**Subject: Bid Package #2**  
Abbott Middle School HVAC Replcmt-DSA 01-119556  
George Hall Elementary School HVAC Replcmt-DSA 01 119523  
Laurel Elementary School HVAC Replcmt DSA 01-119551  
**San Mateo - Foster City School District**

**ADDENDUM NO. 1**

**Subject:** Abbott Middle School HVAC Replacement  
San Mateo - Foster City School District  
Aedis Project No. 2021005.06  
DSA Application #01-119556

### ADDENDUM NO. 1

DATE 11/24/2021  
JOB # 2021005.06  
SHEET # AD1-A2.01

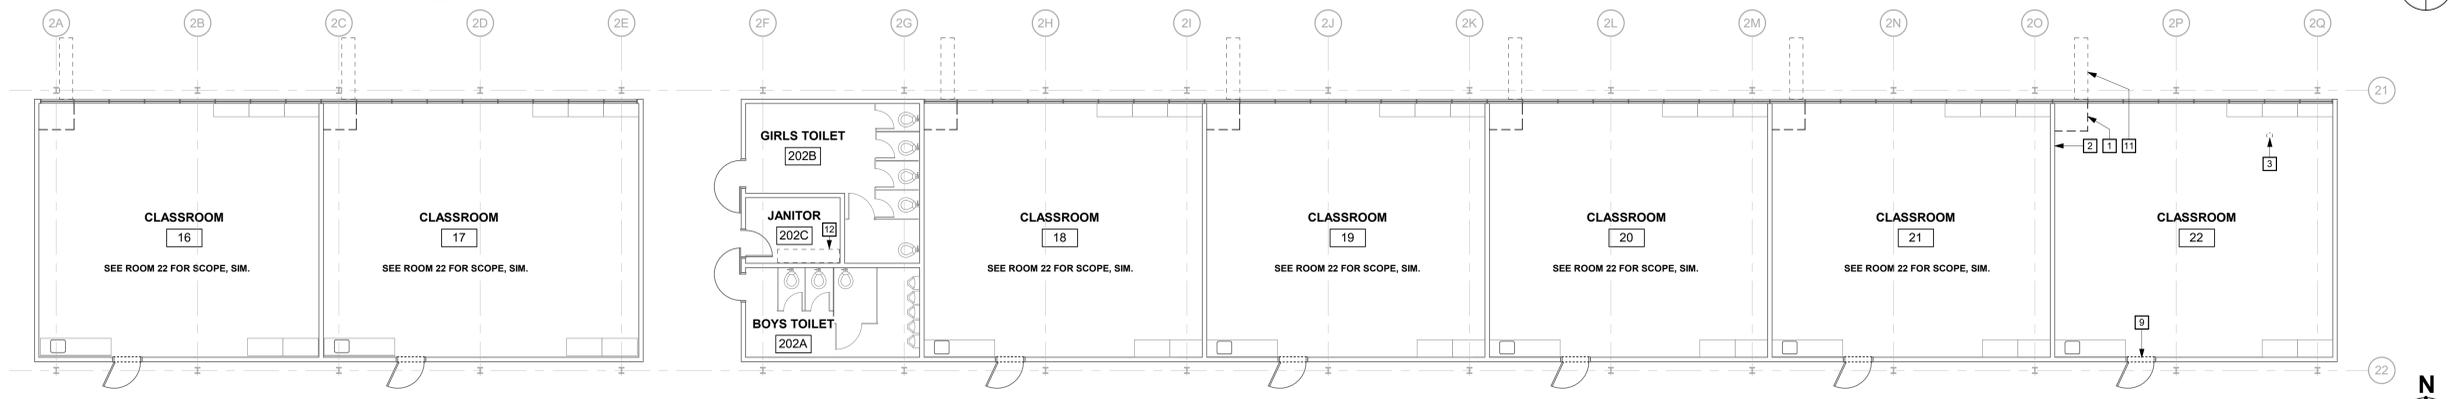
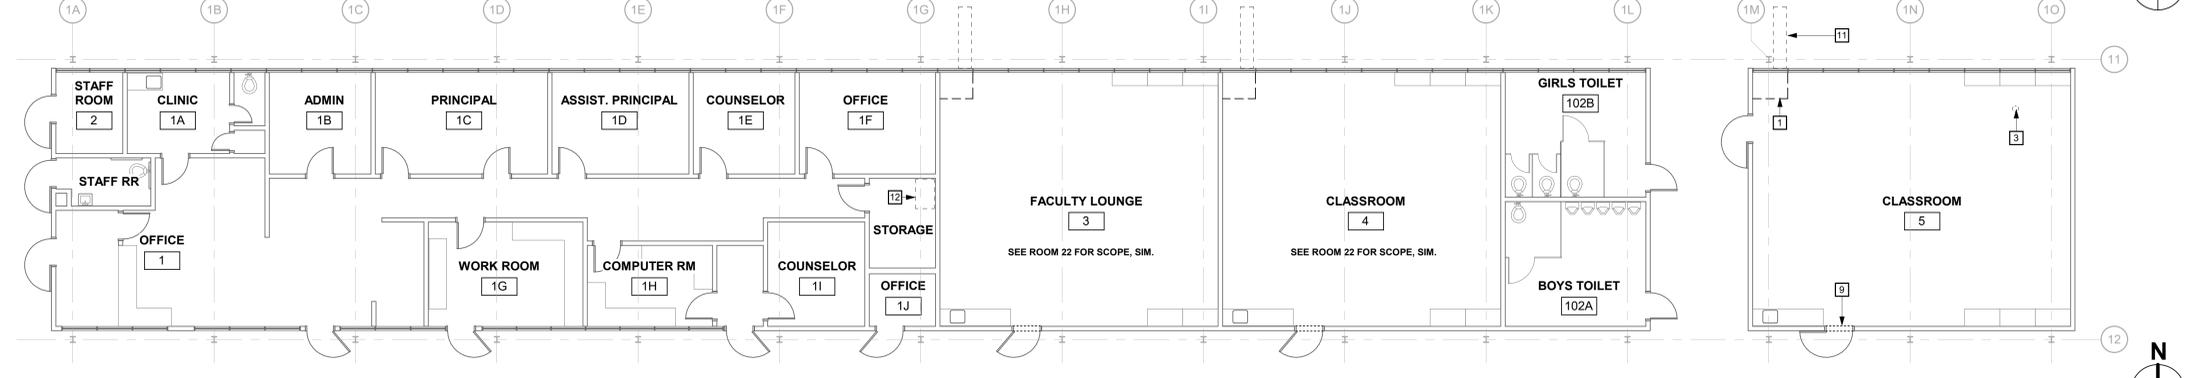
ITEM NO. 1.9:     DRAWING SHEET A2.01 – DEMOLITION FLOOR PLAN – WINGS 1, 2, & 3

Add:        General Sheet Note #I per AD1-A2.01

15 REMOVE (E) MECH EQUIPMENT & INFILL PANEL FOR NEW WORK ▲

ABBOTT MIDDLE SCHOOL - HVAC REPLACEMENT	
		SAN MATEO-FOSTER CITY SCHOOL DISTRICT	
387 S. 1st Street, Suite 300 San Jose, CA., 95113	tel: (408) 300 - 5160 fax: (408) 300 - 5121	FILE NO.: 41-26	SHEET
		APPL NO.: 01-119556	<b>AD1-A3.01</b>
		JOB NO. 2021005.06	
		DATE 11/24/2021

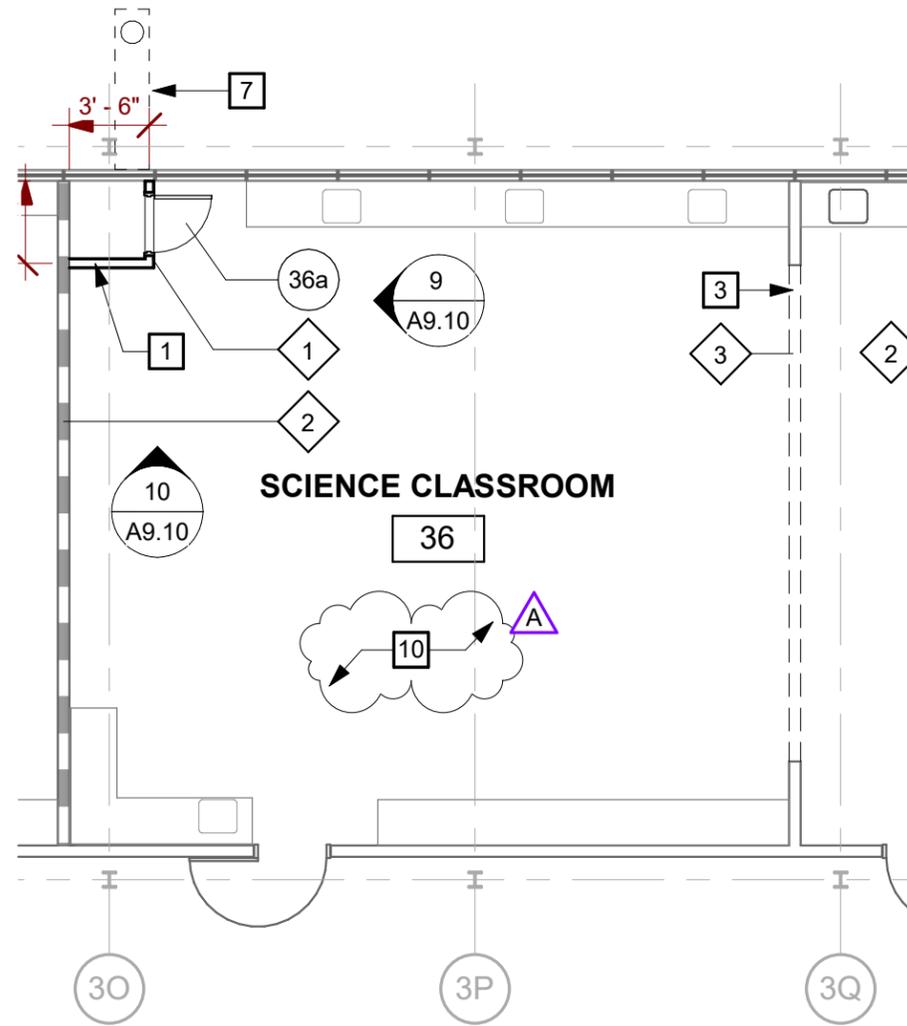
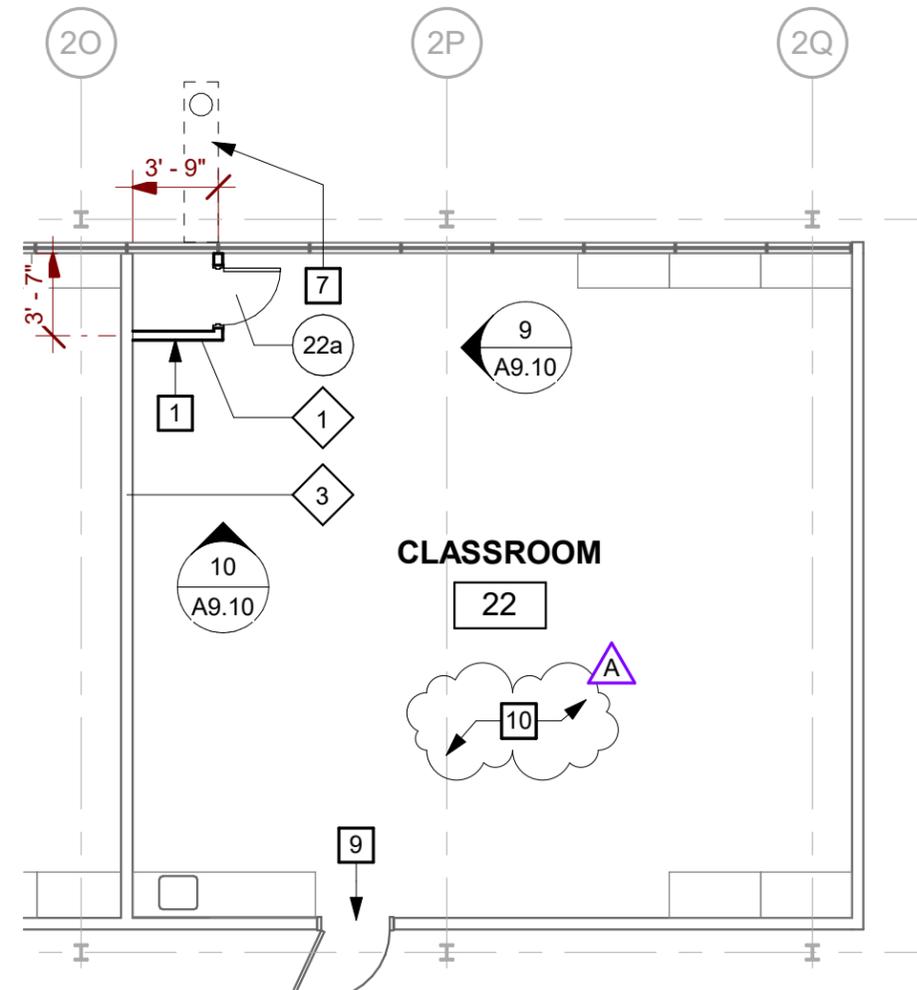
ITEM NO. 1.11:    DRAWING SHEET A3.01 – NEW FLOOR PLANS -WING 1, 2 & 3

Add:        RCP and construction access keynote #10 at 1/A3.01 and 2/A3.01 per AD1-A3.01

- 8 INTERIOR CONDUIT ENCLOSURE, SEE 20/A9.10 AND S.E.D.
- 9 DAMPER @ (E) WINDOW FRAME, S.M.D.
- 10 REFER TO 2/A4.01 FOR TYPICAL CLASSROOM NEW REFLECTED CEILING PLAN. REMOVE AND REINSTALL (E) ACOUSTICAL CEILING TILES ABOVE AS REQUIRED FOR CONSTRUCTION ACCESS INCLUDING BUT NOT LIMITED TO ELECTRICAL ROUTING, MECHANICAL DUCTWORK ANCHORAGE, BLOCKING FOR ROOFTOP PLATFORMS. DO NOT ALTER SUSPENDED A.C.T. GRID.

1 SITE ROOF PLAN  
SCALE: 1/32" = 1'-0"

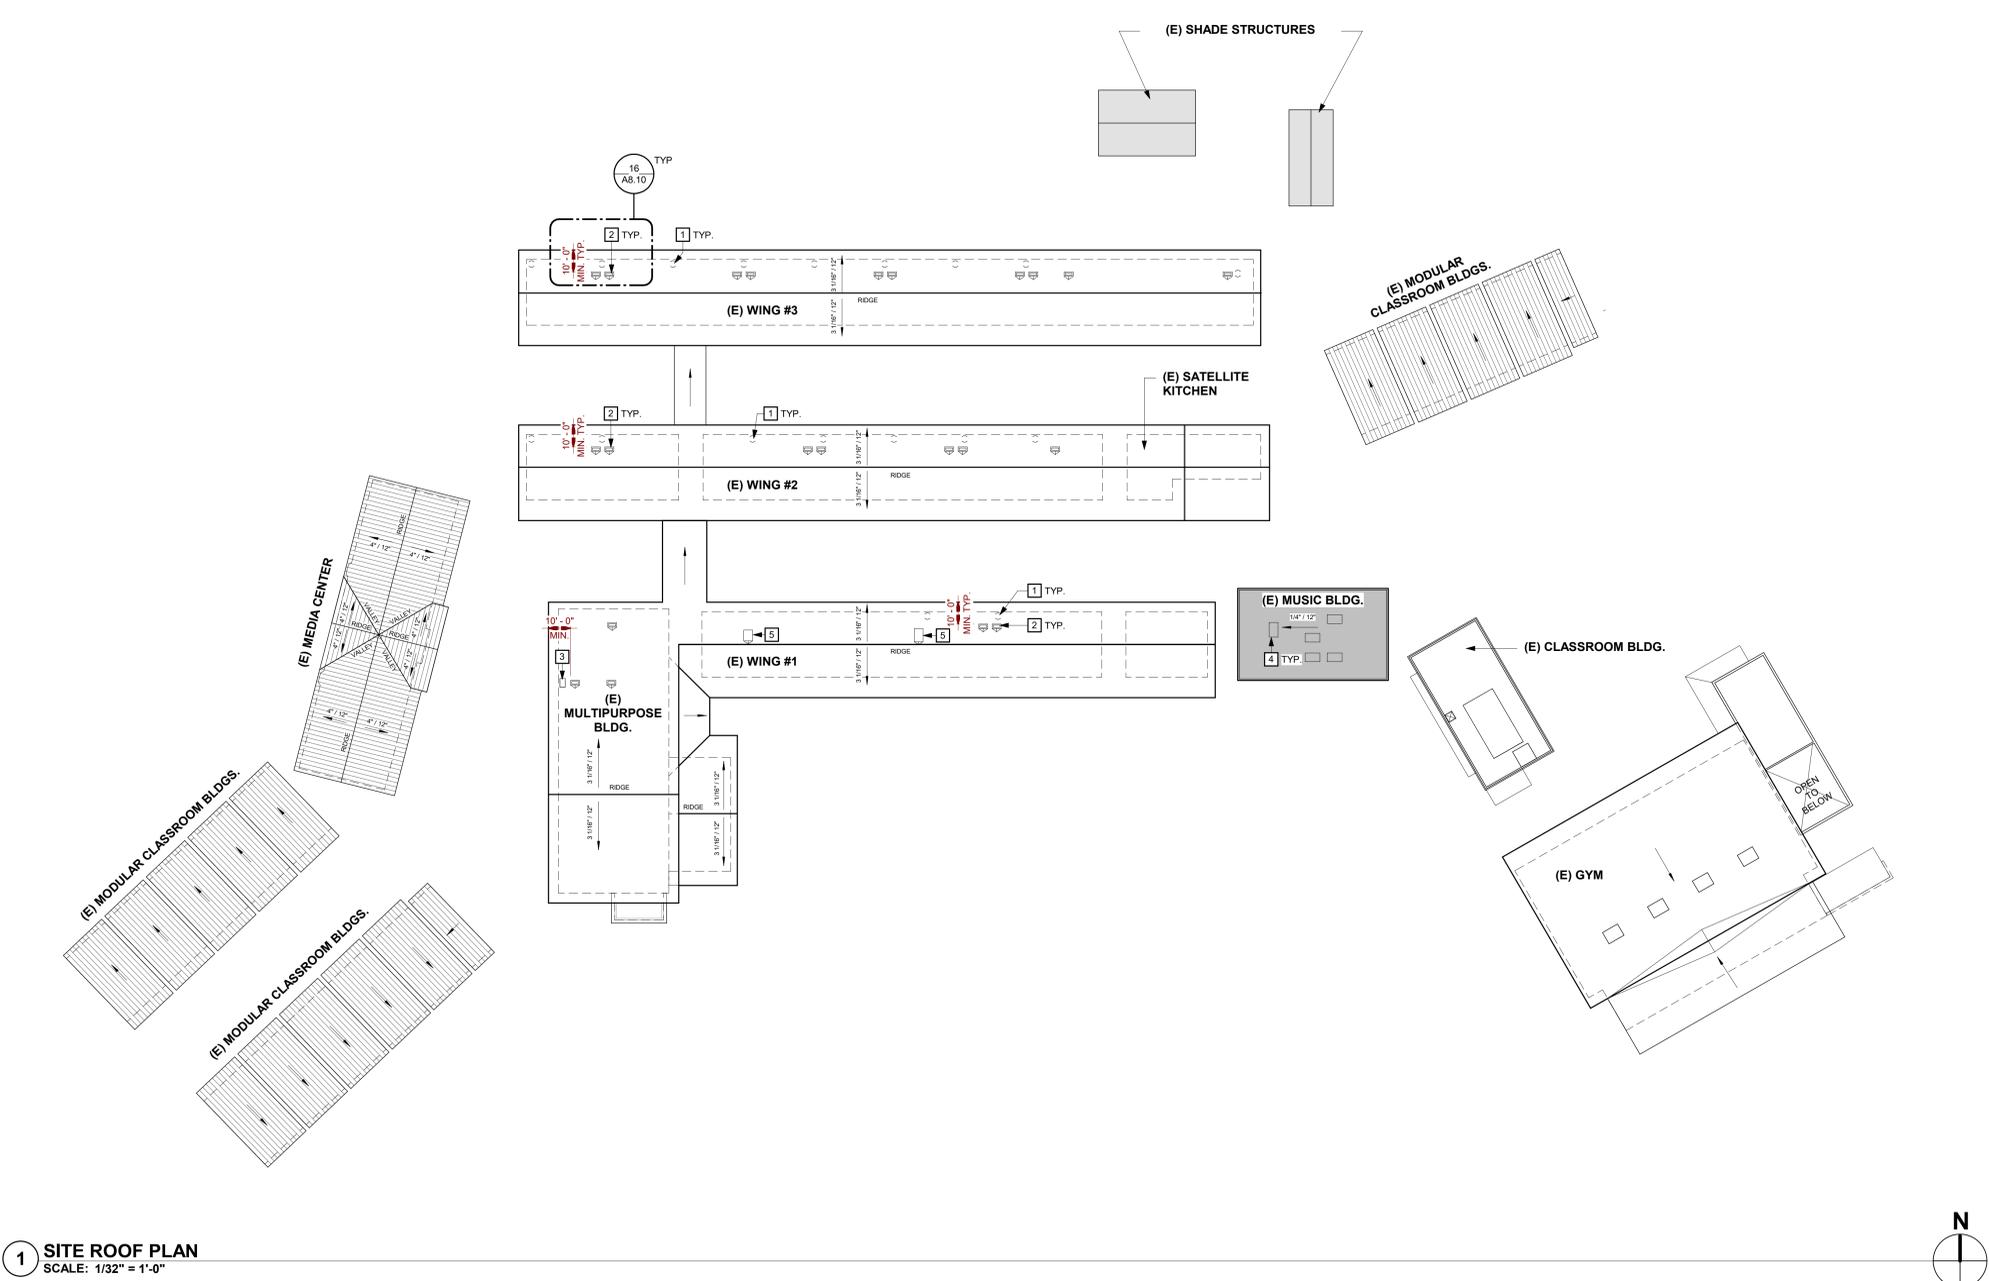
ITEM NO. 1.12:    DRAWING SHEET A5.01 – SITE ROOF PLAN

Revise:     Graphic Key per AD1-A5.01  
Revise:     Roof plan Keynotes #2, #4 & #5 per AD1-A5.01

- 1 PATCH (E) PENETRATION AT REMOVED FLUE AND COMBUSTION AIR INTAKE AND PATCH (N) PENETRATIONS, S.M.D. AND SEE DETAIL 17/A8.10
- 2 MECHANICAL UNIT ON PLATFORM WITH CRICKET, S.M.D. AND SEE DETAIL 10/A8.10. REMOVE (E) ROOFING TO SUBSTRATE FOR CONSTRUCTION ACCESS.
- 3 (E) AIR INTAKE TO REMAIN, S.M.D.
- 4 MECHANICAL UNIT, S.M.D. REMOVE (E) CURB AND REPLACE WITH NEW IN SAME LOCATION, S.M.D. AND SEE DETAIL 19/A8.10
- 5 MECHANICAL UNIT WITH CRICKET, S.M.D. AND SEE DETAIL 10/A8.10. REMOVE (E) CURB AND REPLACE WITH NEW IN SAME LOCATION.

**2** **TYPICAL CHAINLINK GATE (SINGLE)**  
SCALE: 1/2" = 1'-0"

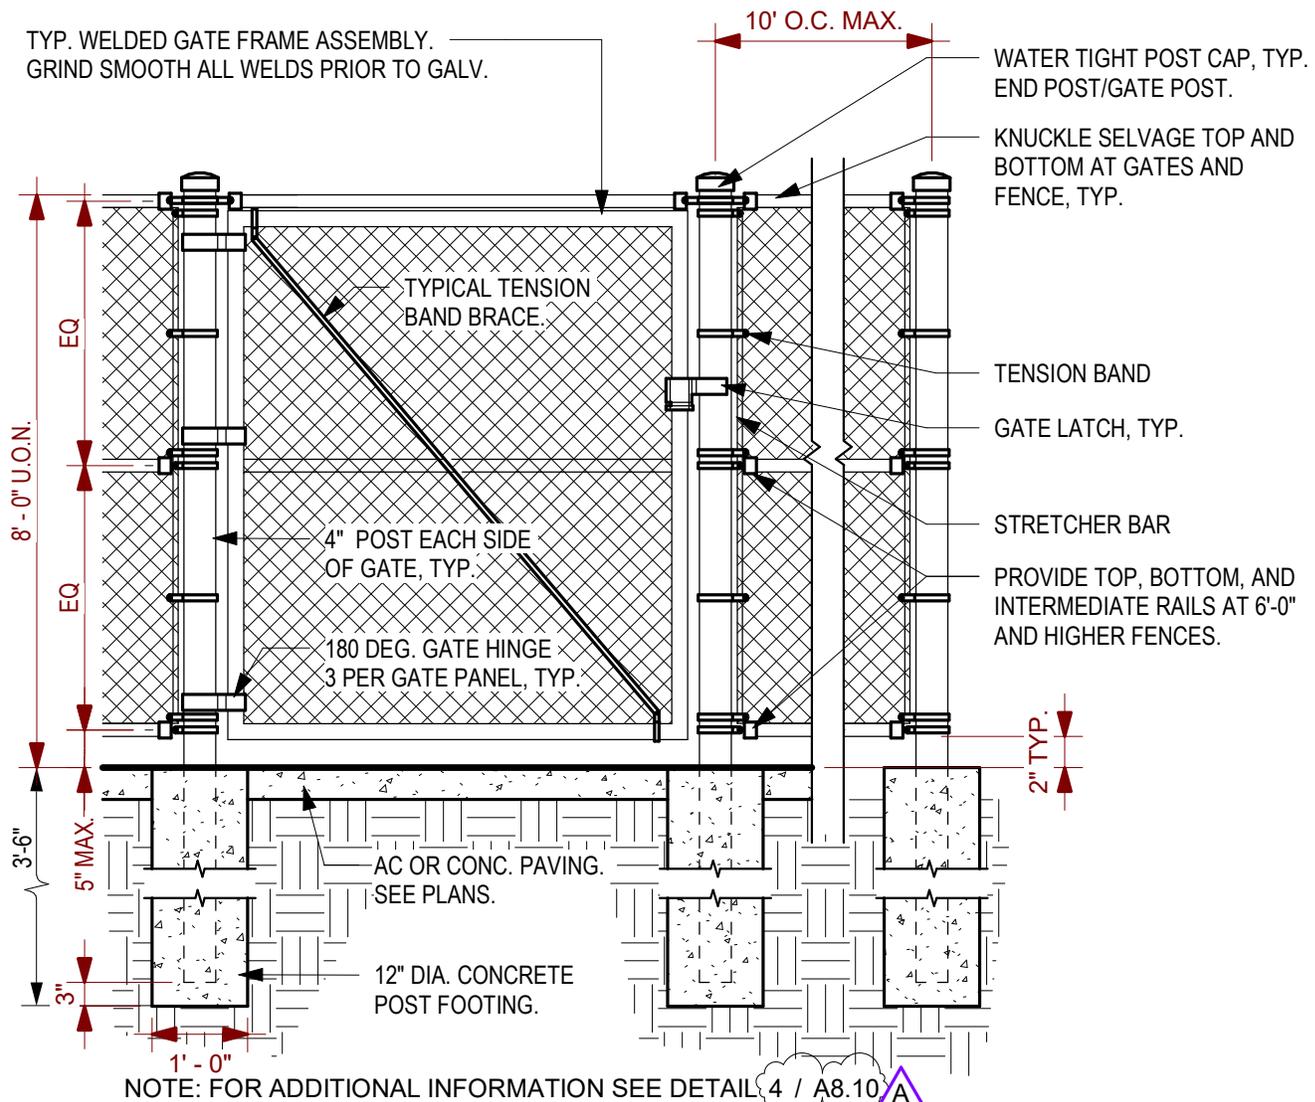
ITEM NO. 1.13:    DRAWING SHEET A8.10 – EXTERIOR DETAILS

Revise:     Detail #2 per AD1-A8.10A  
Revise:     Detail #9 & #19 per AD1-A8.10B

**7 TYPICAL SOUND TREATED NONRATED WALL**  
 SCALE: 1 1/2" = 1'-0"

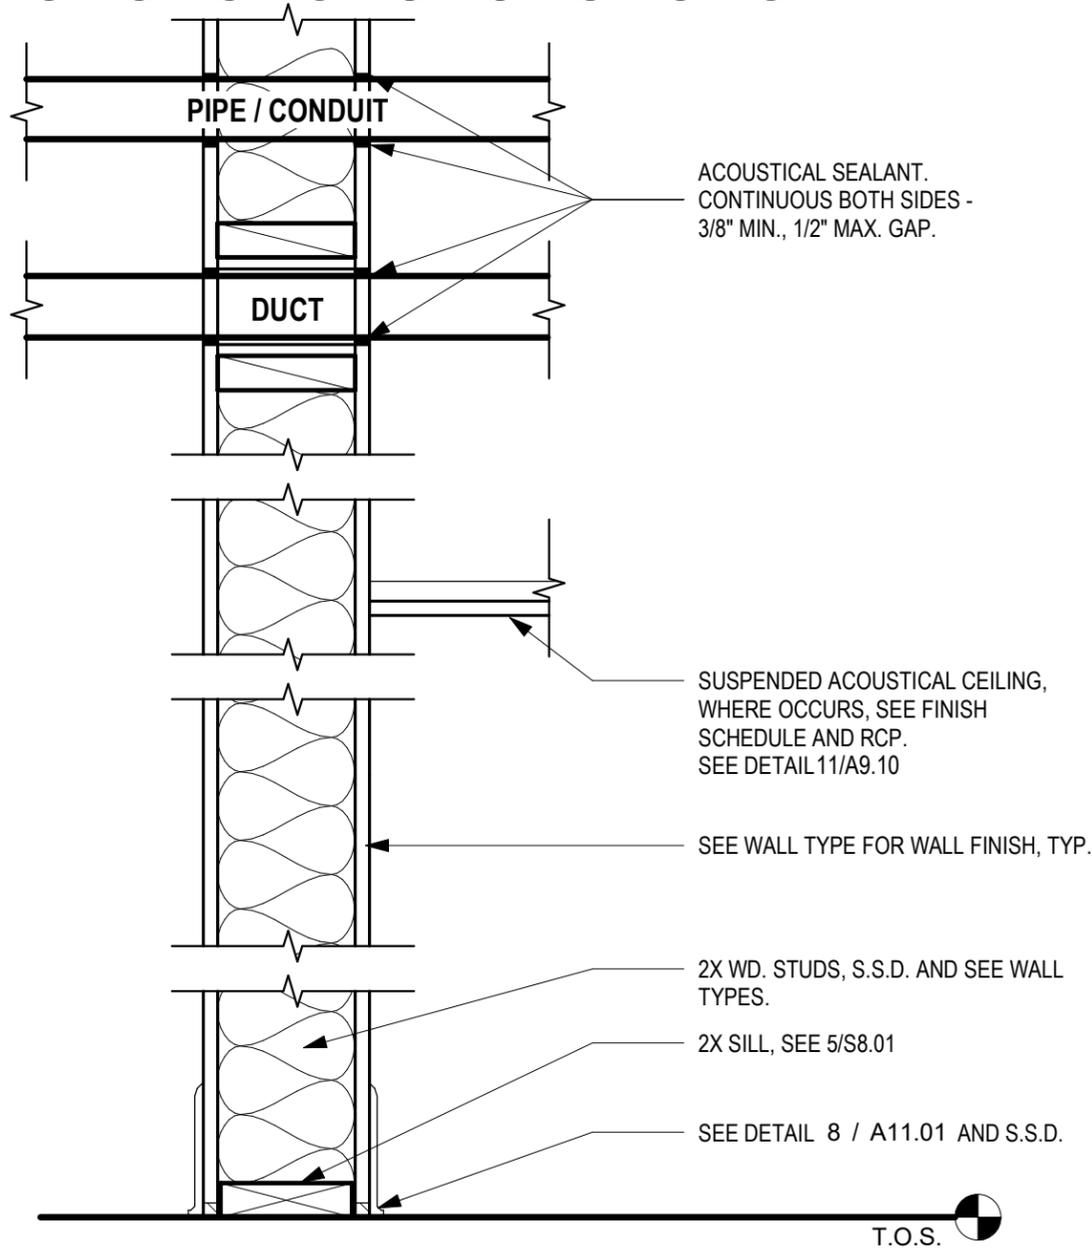
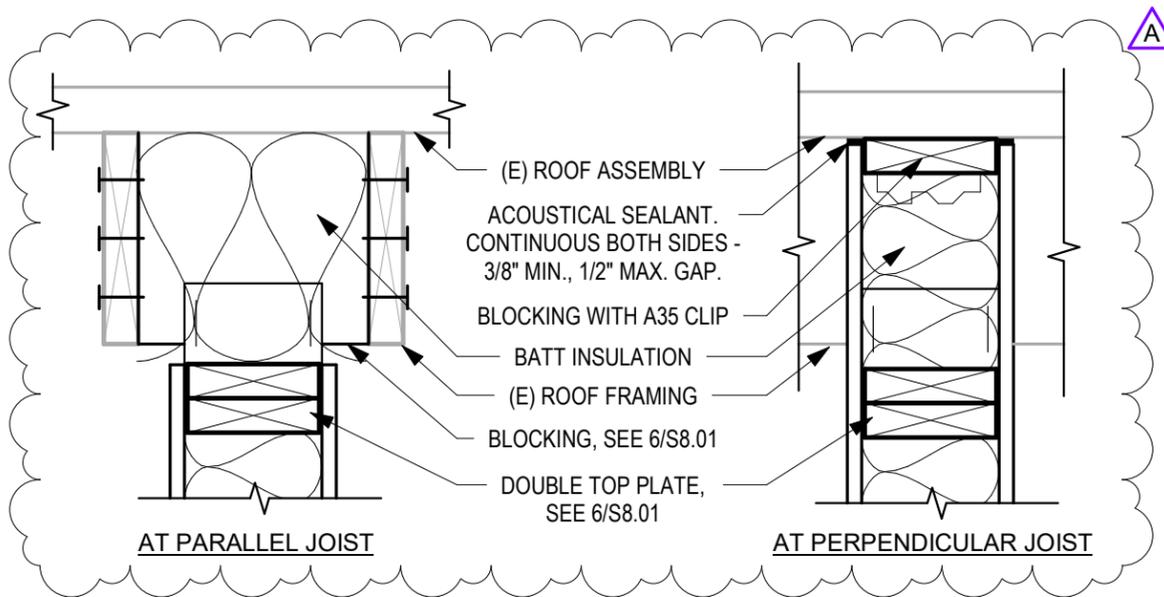
Revise: Detail 7 per AD1-A9.10B
